COLORADO
Division of Reclamation,
Mining and Safety
Department of Natural Resources

Re: Additional Surface Water Monitoring Locations Required, Grassy Valley Surface Water Monitoring; Cresson Project; Permit No. M-1980-244

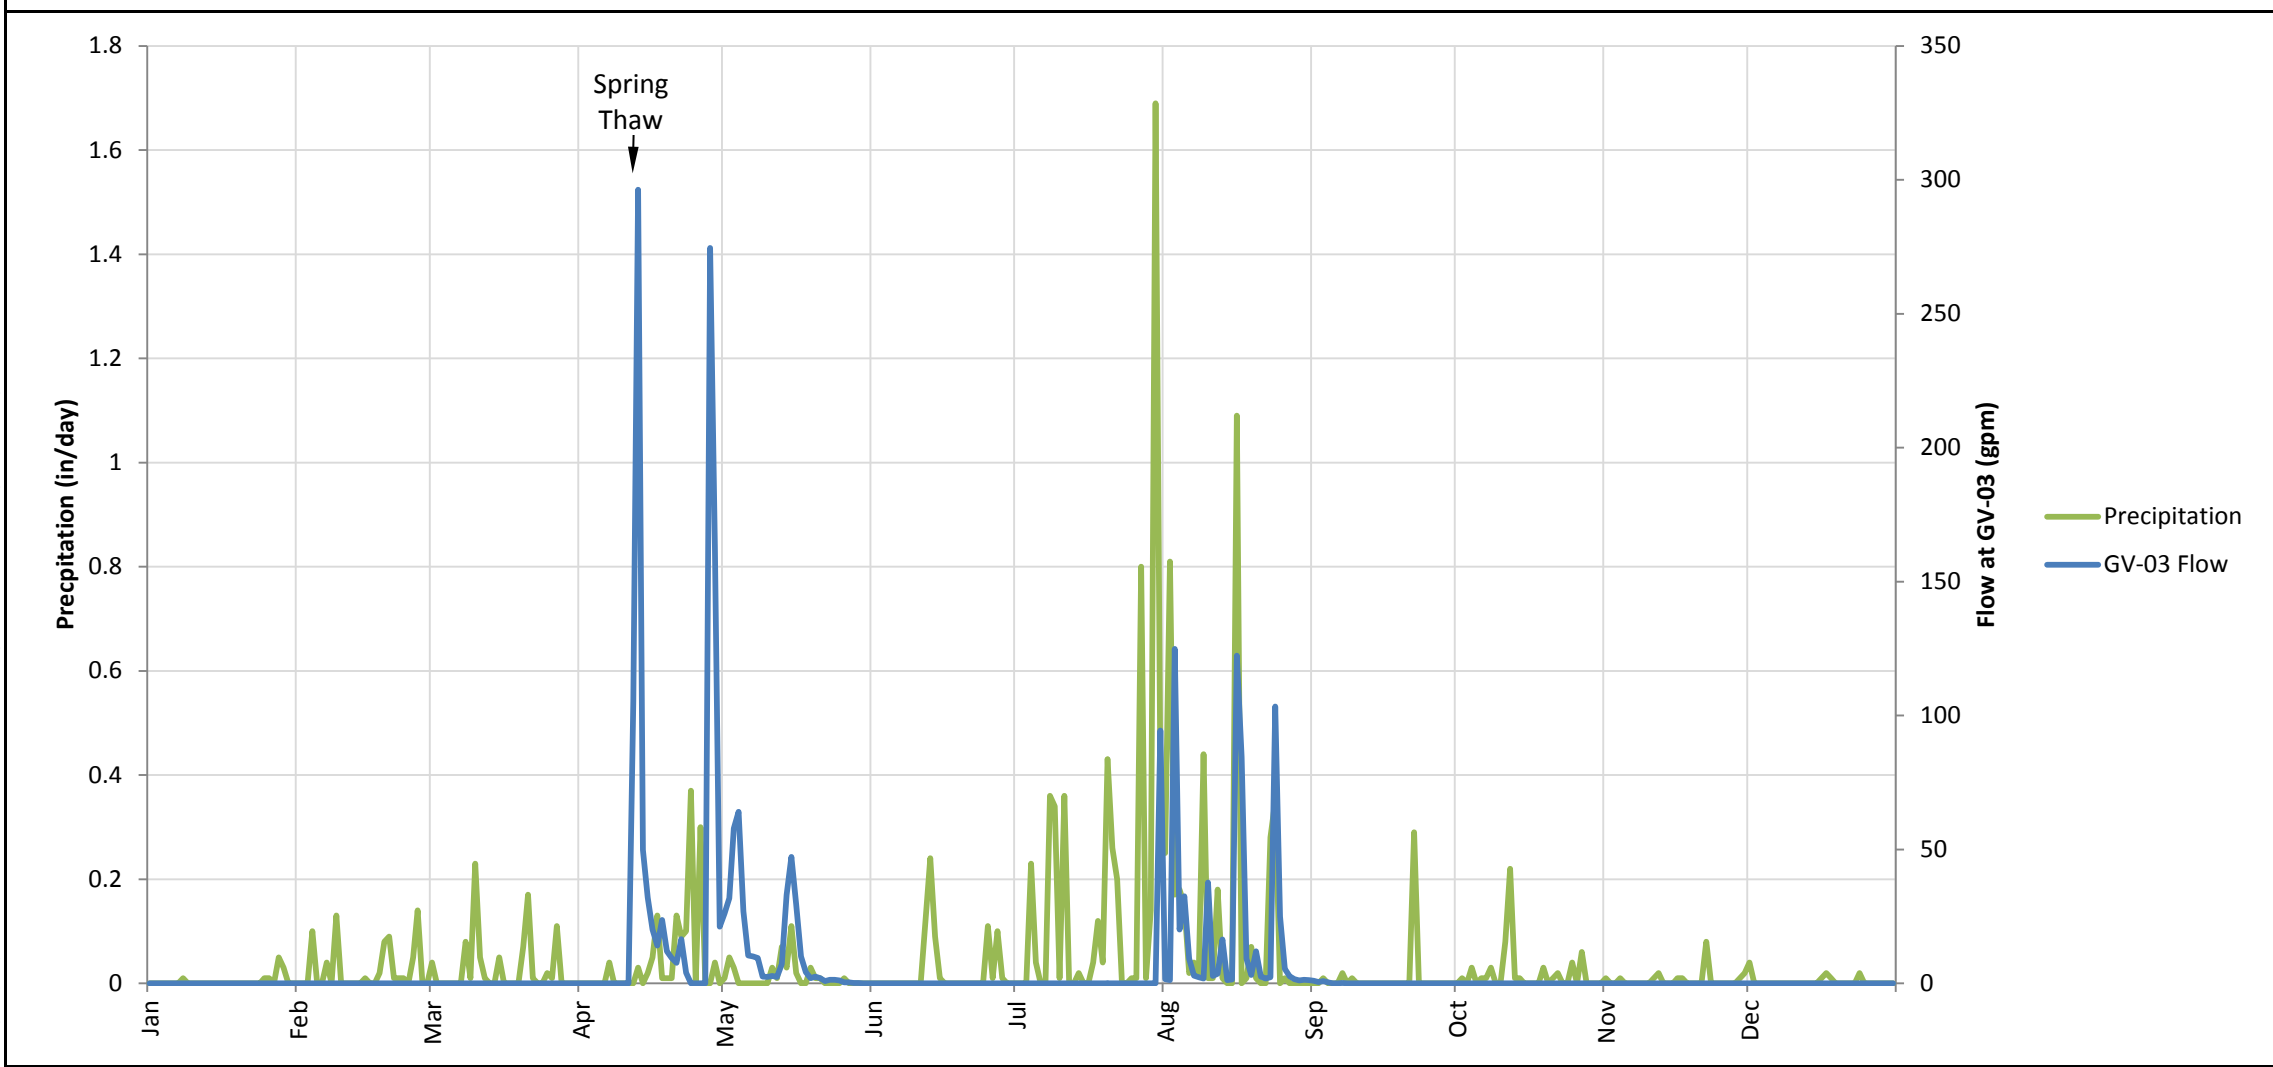
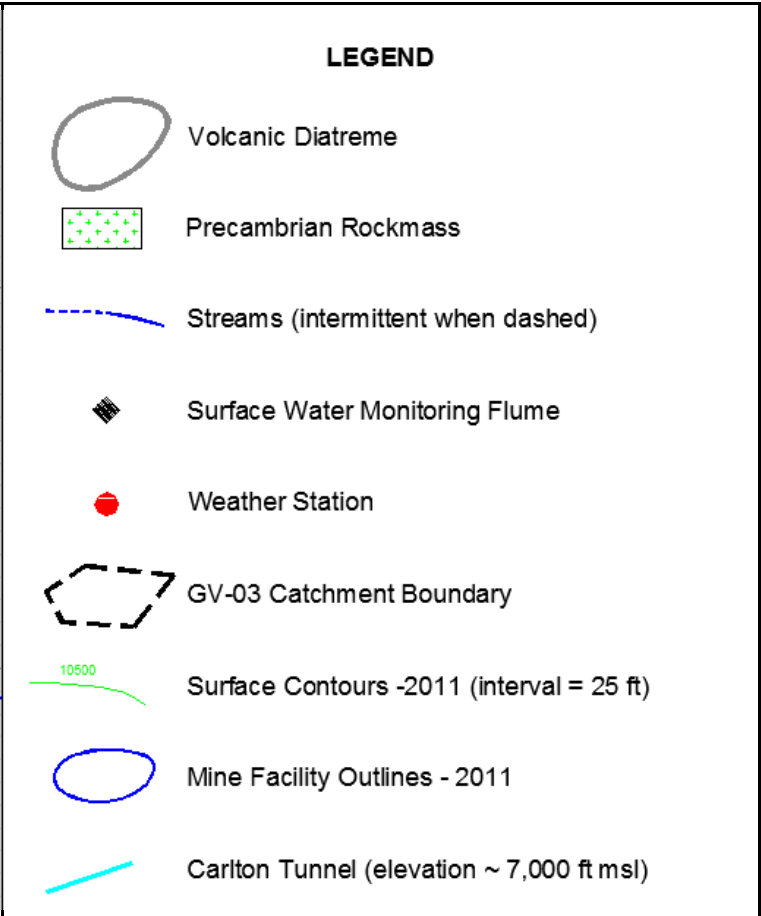
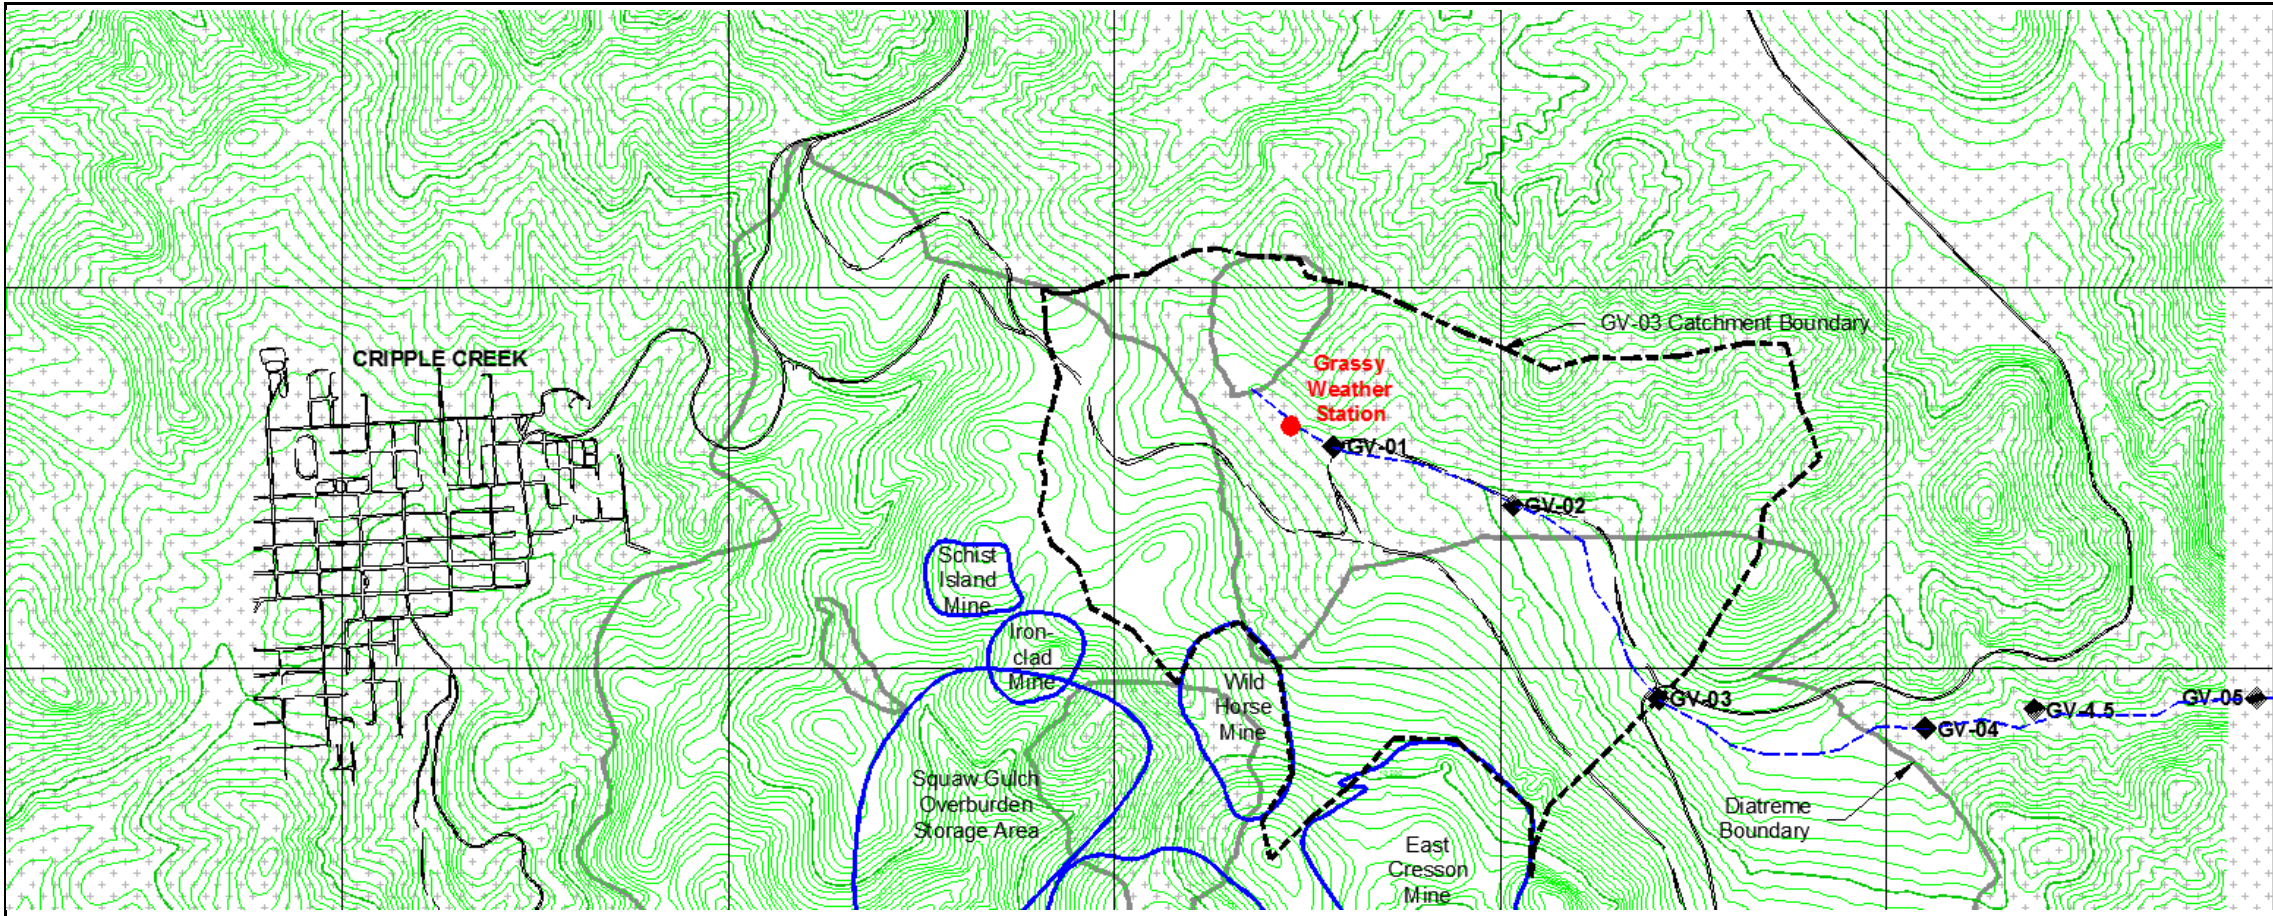
As part of AM-11 filed in December 2015, Adrian Brown submitted a Hydrogeochemistry Evaluation for the site. In this evaluation the principle surface water outflow from the diatreme occurs within Grassy Valley. The flow in Grassy Valley was monitored using six surface water (flume) locations (Plate 7,

attached); GV-01, GV-02, GV-03, GV-04, GV-4.5 and GV-05. It appears from this plate that the current GV-06 location matches the location of GV-04 however, the Operator should verify if this is the case or not.

To ensure compliance with Rule 3.1.5(10), 3.1.5(11), and 3.1.6(1) and based on the increase in total arsenic and iron (total and dissolved) concentrations at GV-06, the Division is expanding the weekly surface water monitoring requirements to include locations GV-04 (unless GV-06 and GV-04 are one in the same), GV-4.5, and GV-05 surface monitoring flumes from the AM-11 documents, until further notice. Samples will be analyzed and compared with the appropriate Reg. 32 stream standards. Along with the results of the first sampling attempt, the Operator will provide the coordinates of each location in decimal degrees. After weekly samples for all four locations have been obtained and the results reviewed the Division may reduce the sampling frequency.

The Operator will provide the Division all historic analytical results for GV-04, GV-4.5, and GV-05 within 30 days of the date on this letter, by **April 12, 2024**.
